April 20, 2021

Re: Proposed Multifamily Development – 55 Summer St Peer Review of Applicant’s January 2021 Submission

PEER REVIEWER COMMENTS – STORMWATER MANAGEMENT

Figure 1. Infiltration Pond #1 Riprap Apron

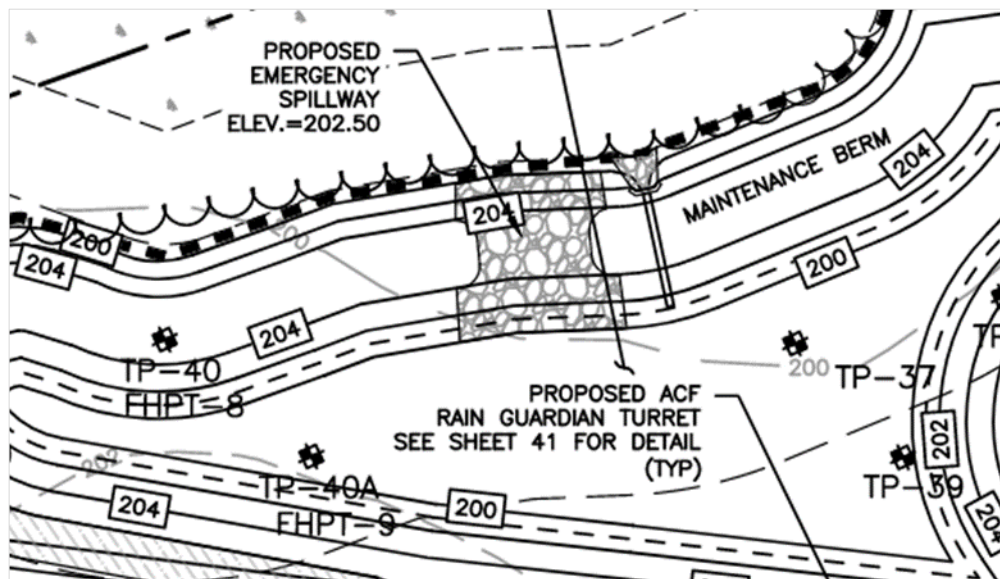
BETA2: Provide riprap apron for outfalls for Infiltration Pond #1 and Extended Detention Wetland #1.

Applicant: Agree – Riprap aprons have been added to both Infiltration Pond #1 and Pocket Wetland #1 and can be seen on sheet 45 and 46 of the plan set.

Figure 5. Test Pit Symbol with Falling Head Permeability Test Labeled

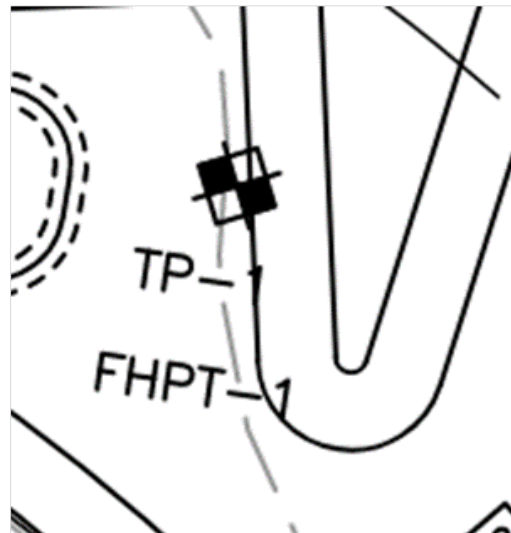
BETA2: *The Applicant has completed in-situ hydrologic conductivity tests and revised the basin models to use these rates. Clarify locations of falling head permeability tests on the plans (OTH- 1 to OTH-52).*

Applicant: *Symbols have been shown on updated plans and are labeled with FHPT-#.*

Locations where falling head permeability tests were conducted have been marked on the plans. The locations have been denoted with FHPT (Falling Head Permeability Test).

Figure 10. Drip Edge Outlets

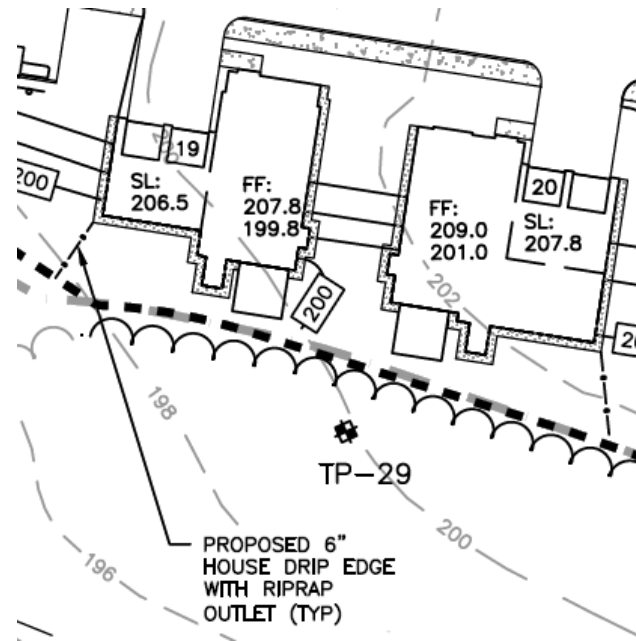
SWA3. *Indicate proposed outlet locations for underdrains from house drip systems.*

Applicant: the underdrain outlet locations are depicted on the Grading Plans, sheets 17-21 of the plan set. See figure 10.

Figure 11. Stormtech Infiltration System (P204)

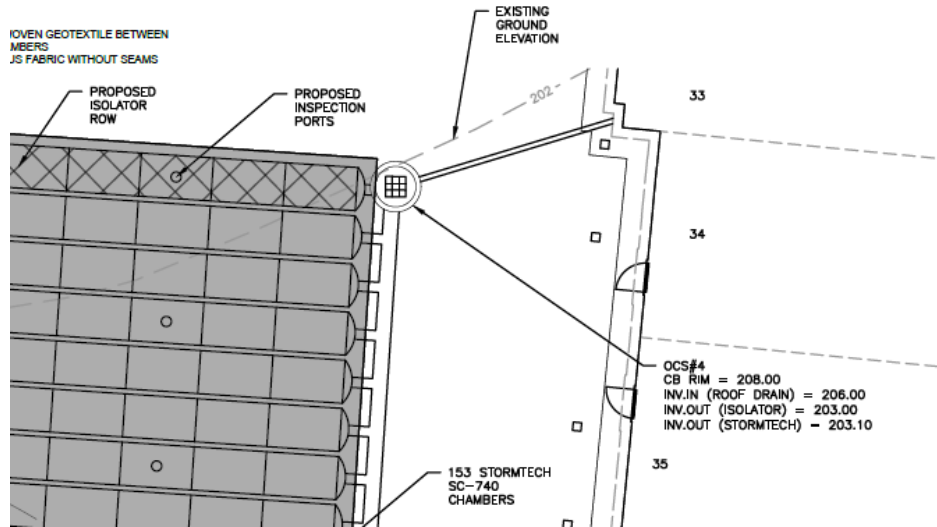
SWA4. Clarify how runoff from S208 will be conveyed to Pond P204. Grading suggests that flow will be directed overland to the nearby wetland system which is inconsistent with the HydroCAD model.

Applicant: All runoff included in Subcatchment S208 has been directed to an outlet control structure with a catch basin grate which will be routed to the subsurface infiltration system (P204) before being discharged to the surrounding area. Once discharged, the runoff will be directed to overland flow and then directed to Analysis Point #4 (AP4). This information can be located on sheet 49 of the plan set. See figure 11.

Figure 12. DMH-9 (Contech water quality unit)

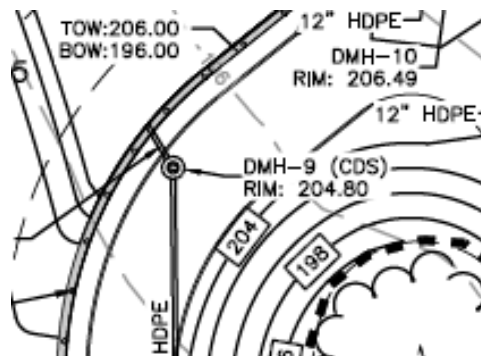
SWA5. Clarify if DMH-9 is intended to be installed as a water quality unit or other proprietary treatment structure to provide the necessary 44% pretreatment to Pond P207. If so, provide associated detail and supporting calculations for removal capacity.

Applicant: DMH-9 will be a Contech Water Quality Unit – STC 900. All necessary TSS removal calculations have been provided in the stormwater report on page 17 with an operation and maintenance guide being included as Appendix C within the Operation and Maintenance Report. A detail of the unit has been provided on Detail Sheet 5 of the plan set and labeled on sheet 18 of the plans well.

Figure 13. ACF Rain Guardians

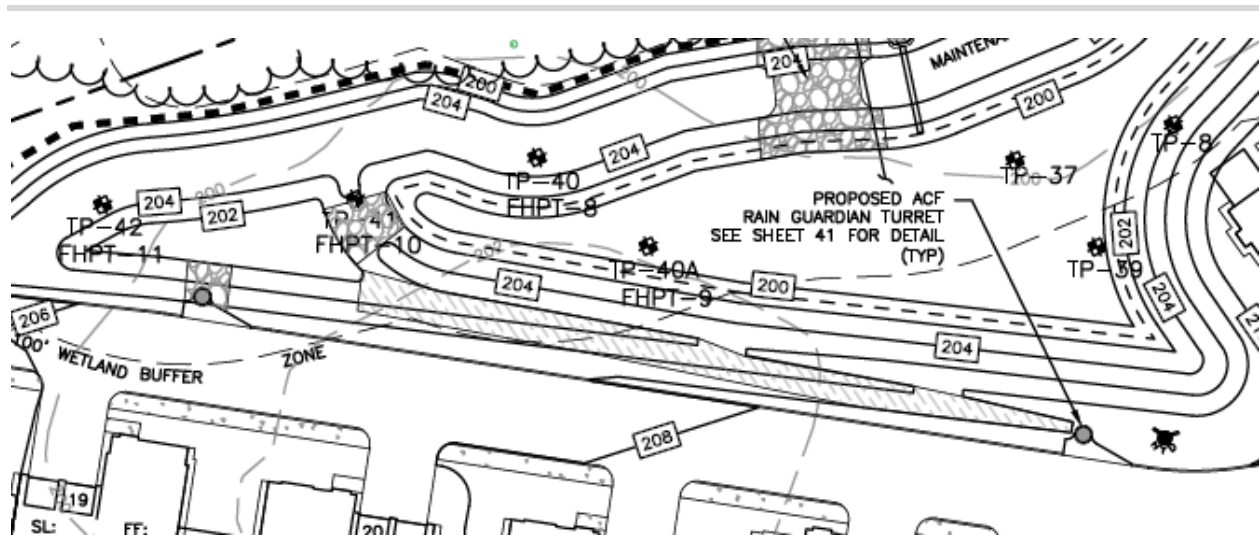
SWA6. Runoff from Watershed S210 to Pond P212 is required to meet the 44% pretreatment requirement for areas with rapid infiltration rates (>2.4 in/hr.). The narrative indicates that this is proposed to be accomplished via a grassed channel and sediment forebay. Volume 1, Chapter 1, Page 11 of the Stormwater Handbook indicates that grassed channels only receive TSS removal credit if combined with pretreatment, which has not been provided. Furthermore, a detail and specifications must be provided to ensure the channel is designed in accordance with the Handbook.

Applicant: The addition of two ACF Rain Guardians pre-treatment units have been added. The first Rain Guardian unit has been placed prior to the grassed channel to make it so that the grassed channel receives the full TSS credit and the second one is placed prior to the entry of the sediment forebay so that the combination of the Rain Guardian unit and the Sediment Forebay will also receive the full credit. These units can be found on the Grading Plan, Sheet 18 within the plan set.

Figure 14. Infiltration Basin #2

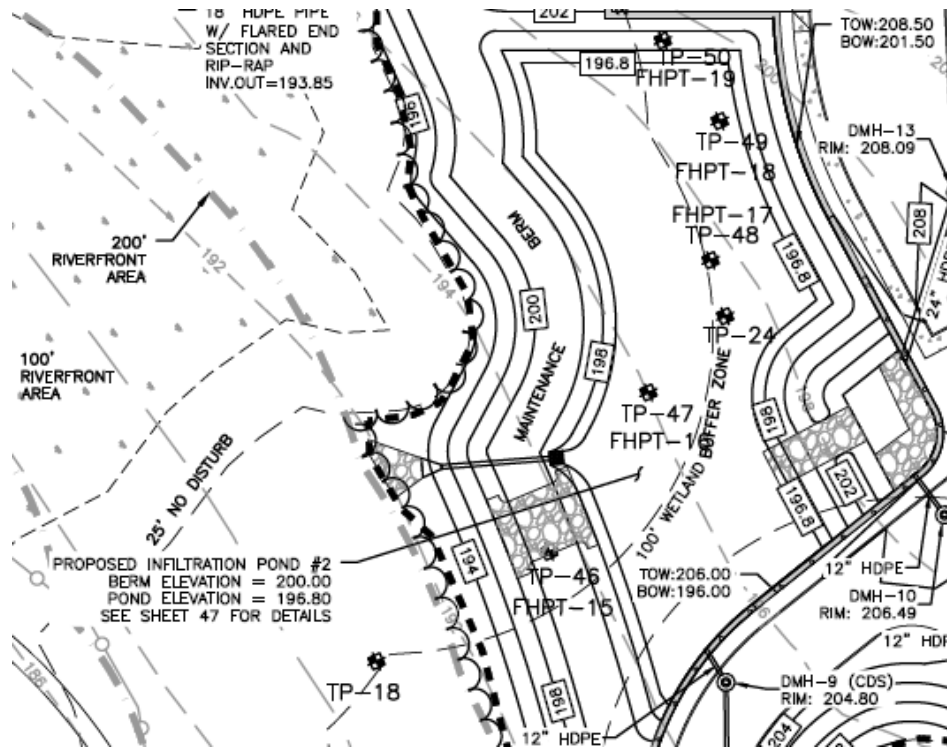
SWA11. Revise design of Infiltration Basin #2 (P207). Test pits TP-47 and TP-48 show seasonal high groundwater elevations of approximately 193.5' and 195'. The basin bottom is at elevation 194', which is not the required 2' above seasonal high groundwater elevation. Of the other test pits completed in this area, TP-49 and TP-50 were not completed to sufficient depth to evaluate groundwater, and TP-24 identified mottling at elevation 193.5'.

Applicant: The design of Infiltration Basin #2 on sheet #17 has been revised to a bottom depth of 196.80' instead of the previous 194.00'.

Figure 15. Infiltration Basin #1

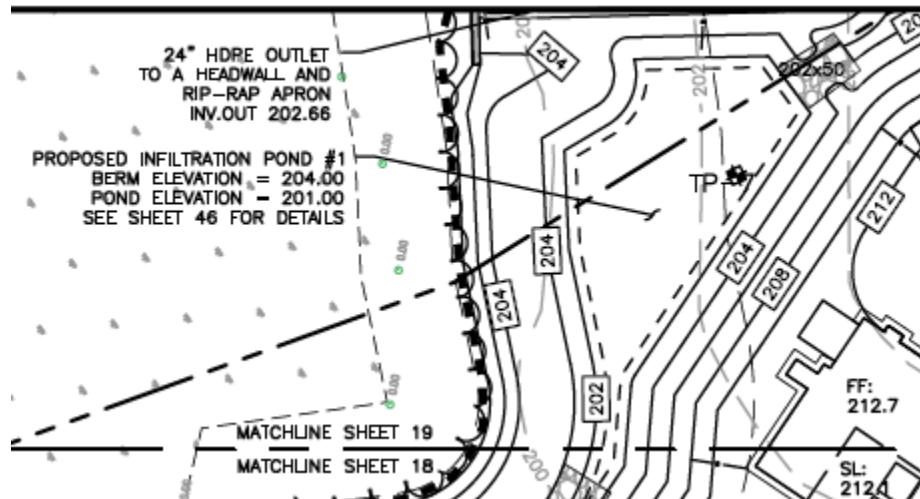
SWA12. Raise bottom elevation of Infiltration Basin #1 (P212) to be at least 2' above seasonal high groundwater. Test Pits TP-40 and TP-40A show seasonal high groundwater at approximately 198.67 ft compared to bottom elevation of 200'.

Applicant: The first cell of Infiltration Basin shown on sheet #18 has been raised by a foot to 201'. This provides at least 2' of clearance between the bottom of the basin and the seasonal high groundwater.

Figure 16. Stream Crossing #1

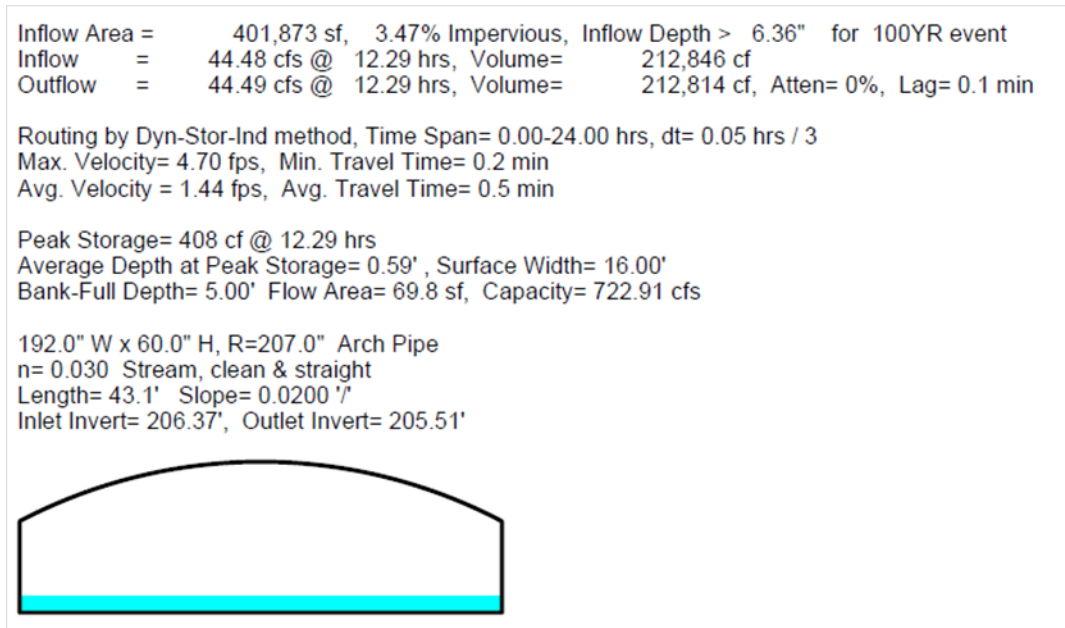
SWA14. Provide hydraulic calculations and inverts for all proposed wetland crossing culverts to ensure they can convey anticipated flows.

Applicant: The proposed wetland crossings have been modeled within HydroCAD and have been attached within the report. The HydroCAD models (page #761 in the Supplemental Data Report) show that the crossings are oversized.

100-year storm event produces a flow depth of 0.59' out of a 5' clear opening.

Figure 17. Before and After removal of Unit 6

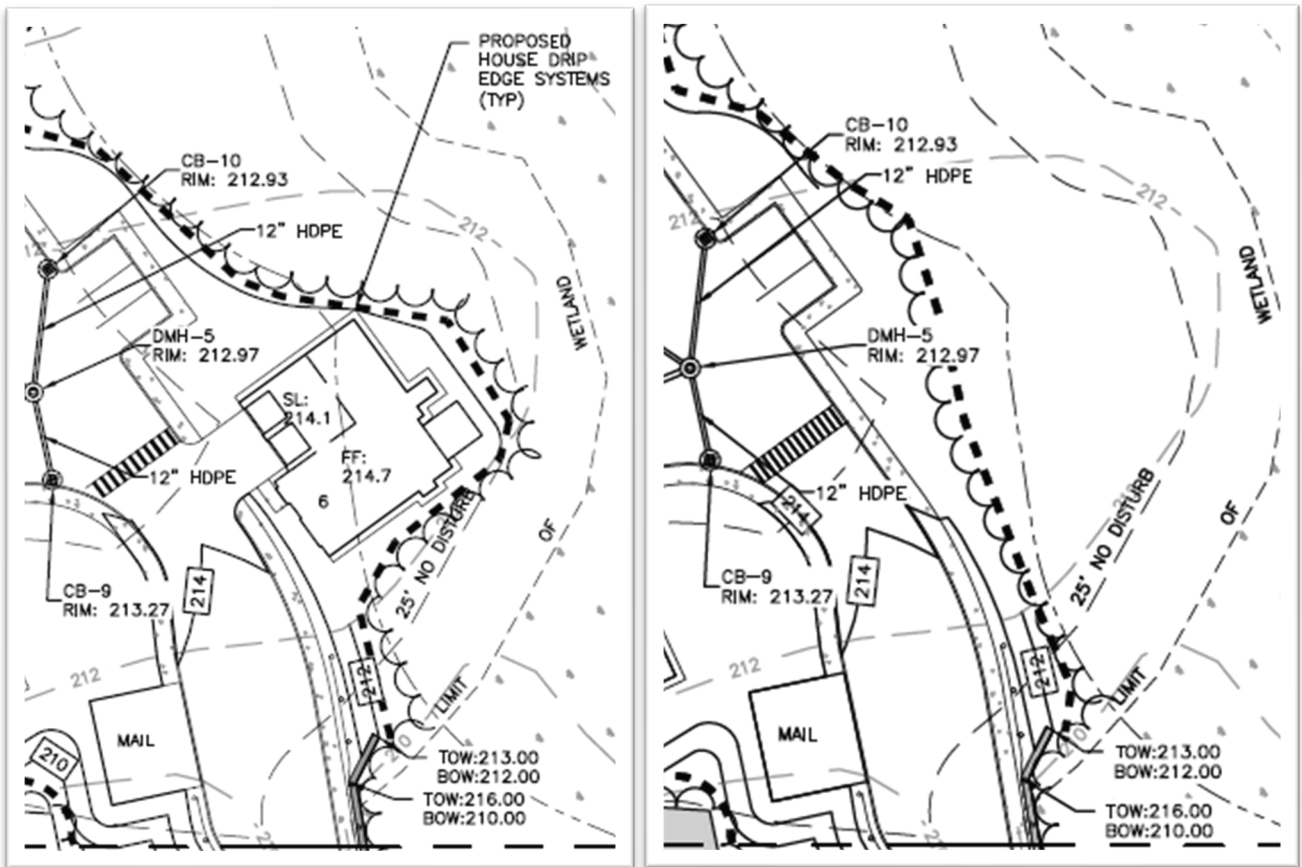
- Eliminate Unit 6 located northwest of VP3. This upland area is important to the migration of VP species to the north towards the 2nd wetland crossing and also provides critical upland habitat. Upland buffer should be maintained between all development and the wetland boundary. This allows some room for wildlife to travel around the wetland as they won't travel through wetlands unless necessary.
 - ***Applicant: Although not a requirement of the WPA, Unit #6 has been removed to maintain as much of this critical upland habitat and buffer.***

Figure 18. Before and After Layout for Units 1-5

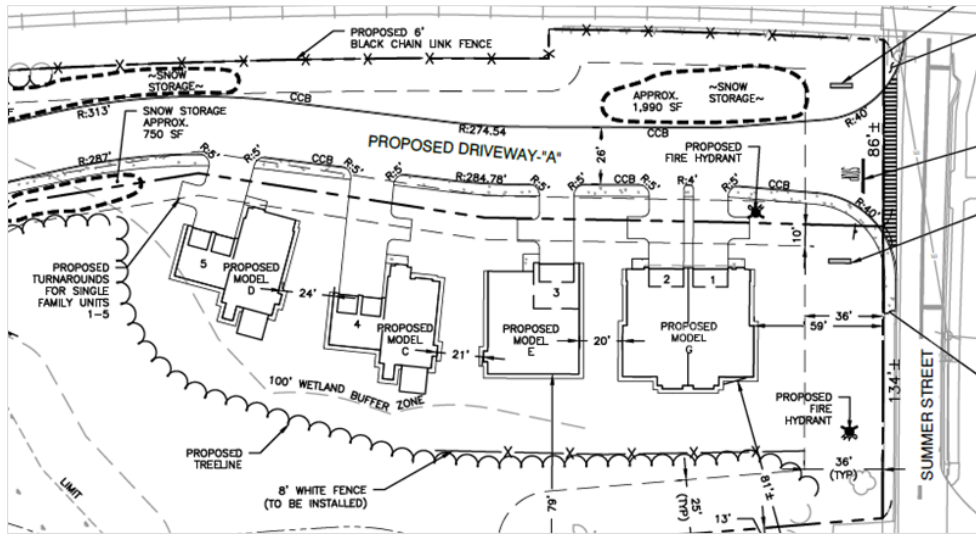
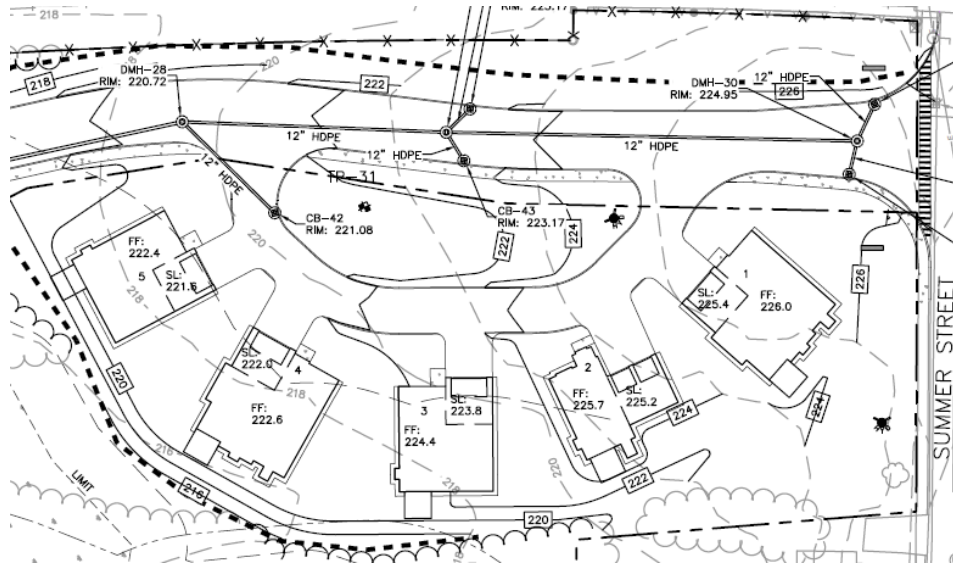
- Provide more upland buffer behind Units 1 through 5 located east of VP3, near Summer Street. This could be accomplished by turning the units or eliminating the cul-de-sac type layout.
 - *Applicant: Although not a requirement of the WPA, units 1-5 have been redesigned to provide more upland buffer behind the units and provide greater separation between the units and the edge of the wetland. Units 1-4 are completely out of the 100' wetland buffer and unit 5 has a corner in the buffer. See the below figure for the layout redesign.*

Figure 19. Removal of the grading and addition of a retaining wall.

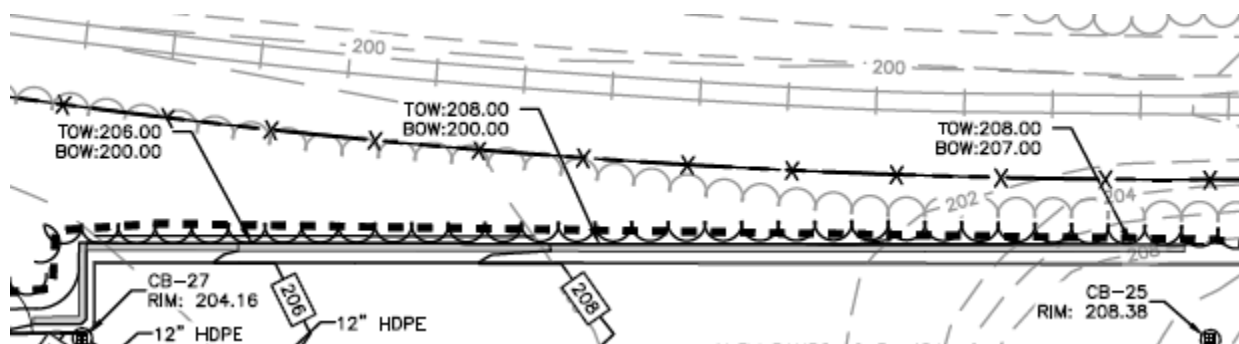
- **Eliminate the proposed Snow Storage area located east of multi-unit Building #1, directly adjacent to the RR ROW fencing. Eliminate the grading, replace with a retaining wall to maintain the only narrow vegetated buffer for the wildlife travel from VPs #1 and 2 to the Riverfront Area / Cedar Swamp Brook corridor. It is critical to maintain a densely vegetated connection in this north – south direction. Otherwise, any safe pathway will be eliminated.**

- **Applicant: Although not a requirement of the WPA, the snow storage and grading adjacent to the parking for the multi-family Building #1 has been removed and replaced with a retaining wall and the tree line has been restored. This change can be found on sheet 17 of the plan set (figure 19). The wildlife corridor parallel to the rail alignment is thus maintained as suggested by BETA.**

Figure 20. Relocation of the Maintenance Building and Dog Park

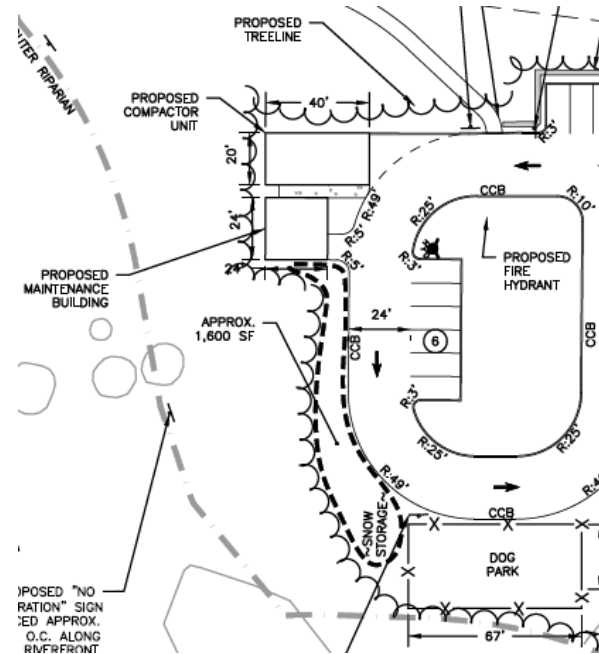
- **Eliminate the proposed Dog Park from its current proposed location. Having a dog park next to a very minimal wildlife travel corridor will disrupt movement significantly.**
 - **Applicant: Although not a requirement of the WPA, the Dog Park has been moved to the west, adjacent to the loop road for the drive under. The Maintenance building has also been moved to the other side of the compactors unit to further minimize the impact to the wildlife corridor. This change can be found on sheet 12 of the plan set.**

Figure 21. 100' Wetland and 200' Riverfront Buffer Sign

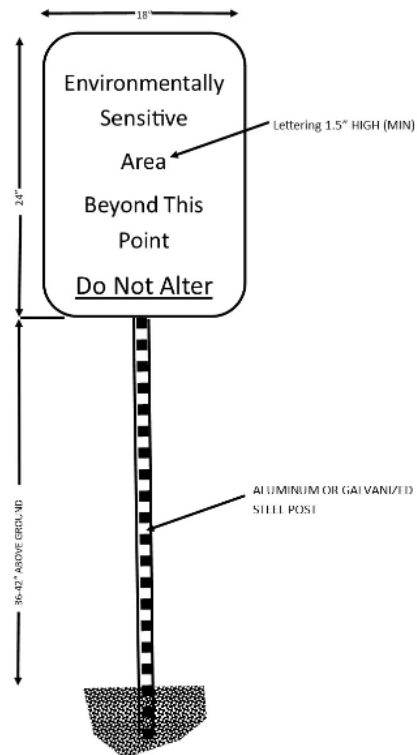
BETA2: *The location of the proposed wetland replication areas requires the removal of mature overstory trees and existing upland vegetated understory. Until the re-establishment of the wetland vegetation, wildlife traveling towards and through the wetland crossing culverts will be exposed and they may avoid using it resulting in isolation of areas. Therefore, at a minimum, these areas should be densely planted and a fence separating the built development from these minimal wildlife pathways.*

Applicant: *The proposed plantings show on sheet 52 of the proposed plan set have been bumped up 10% to help with the density of the replication areas establishment. The applicant has provided signage on the Layout and Materials Plans, sheets 12-16 of the plan set and a natural fence made of arborvitaes to buffer the replication areas from the abutting development.*
